Sea Link

Document 9.79: Applicant's Comments on Written Representations

Planning Inspectorate Reference: EN20026

Version: A
December 2025

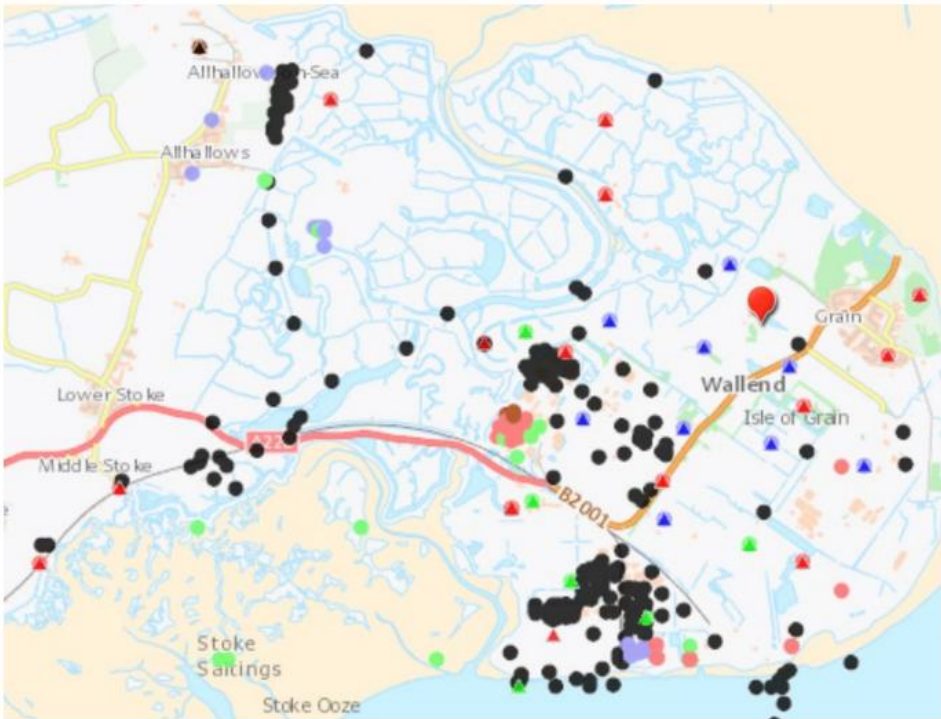
5	The proposed construction of the Converter Station will cause vast damage irreversible damage to The Marshes and River Stour.	1. Temporary Haulage Roads. Temporary haulage roads will have to be constructed along which vehicles can move without sinking into the ground, especially in winter. 2. Construction of Converter Station. So far basic details have not been provided: a. Area of building b. Load exerted by building on ground c. Foundation design. 3. One carries on loading the soil until it stops compressing; this is when sufficient water squeezed out to top settlement. This is not practical at this site. The design has not been submitted but what may be needed is to construct a platform raised above the ground on very large piles sunk into Thanet Sands or most likely, The Chalk. In appearance it will be like a North Sea platform. This will be very expensive and need importation of vast amounts of steel and/or concrete. The machines needed to construct wide deep piles are very large and heavy so will need well built haulage roads. 4. Piling will be required. However, the risk from unexploded bombs made geophysics too risky so how will piling be possible? There is no reason why there cannot be several 100kg bombs located close to each other so detonation from piling causes one to explode and others nearby. What is the result of say 4 bombs exploding with a combined weight of 4000kg? 5. Much of the site will be flooded in winter. One can build bridges across rivers and platforms in the sea but one uses vary large barges with cranes of very high capacity. 6. One could construct a sheet pile around the site or a cofferdam and de-water within but this would be very expensive and create irreparable damage to River Stour and The Marshes. Choosing this site	Temporary haulage roads will be used on the project as a standard mitigation for protecting the subsoil across the site. The routing of the permanent access road also forms part of the temporary haulage road network to combine works. The area of the Converter and Substation sites have been provided within the submission within the Application Document 2.5.2 Works Plans [REP1-002] and Typical layouts which include building sizes are provided within Application Document 2.13 Design and Layout Plans [APP-037]. Building loadings and detailed foundation designs are not required to inform the DCO process and shall be developed at detailed design. Piling is required at the site and access for piling rigs has been assessed as part of the project development. No North Sea platforms are proposed as part of the is project. UXO risks will be managed during any piling process through the use of Magnetometer surveys, similar to those undertaken during the bore hole works undertaken as part of the ground investigation. The Flood Risk Assessment that has been prepared (Application Document 6.8 Flood Risk Assessment [APP-292]) presents flood zone mapping for the Kent Project (Figure 1C for construction elements and Figure 1D for operational infrastructure). The figures show that Flood Zones 2 and 3 have largely been

Water table in London Clay below 30m bgl. BH BGS ID 635750, BGS TQ87NE16, NGR 586120,175740 Depth 12m Drift 52m London Clay 72m Reading and Woolwich 12 78m Thanet 250 m Chalk There has been extensive industrial construction on the Isle of Grain so there is the knowledge of how the ground behaves under load.

Reference	Matter	Points Raised	Applicant's Comments
		Underlain by London Clay with Chalk at depth BH BGS ID 756338, BGS Ref TQ87SW85 , NGR 580790, 175840 Depth 1.4m bgl Made Ground 2.6m Alluvium 2.8m Terrace Gravel 4.3m London Cly 38.07m Woolwich and Reading, Thanet Beds BH 13 BGS ID 756283, BGS Ref TQ87SW48/c, NGR 580700. 172900 Depth 7.9m Drift 29.0m London Cly 40.2m Black heath, Woolwich and Reading 68m Thanet 147.5m Upper Chalk 206m Middle Chalk 244m Lower Chalk Water struck at 25m bgl. Dungeness 	
7	Summary	1. The proposed construction of the Converter Station on the Minster Marshes will produce vast permanent damage to the marshes and the River Stour. 2. The construction of the Converter Station will be far more technically difficult at the Minster Marshes site compared to Sellinge, Isle of Grain, Kingsnorth Power Station and Dungeness Power station. 14 3. The prosed sites at Sellinge, Isle of Grain an and Dungeness are well above the water table, are located on firm ground and have had construction undertaken nearby. Consequently, there is existing site investigation data and data from the monitoring of structures on the ground. Construction at Sellinge, Isle of Grain, Kingsnorth Power station and Dungeness will be quicker, cheaper and simpler than on the Minster Marshes.	The Proposed Project, including the converter station in Kent, has been developed in accordance with National Grid's approach to project development, as set out in Application document 7.3 Design Development Report [APP-321]. This involves a balanced consideration of various environmental, socio-economic, engineering, and cost factors, which (alongside consultation, ongoing survey work, and back checking) inform reasoned judgements as to what the most appropriate project design to take forward. This has included robust consideration of alternatives.
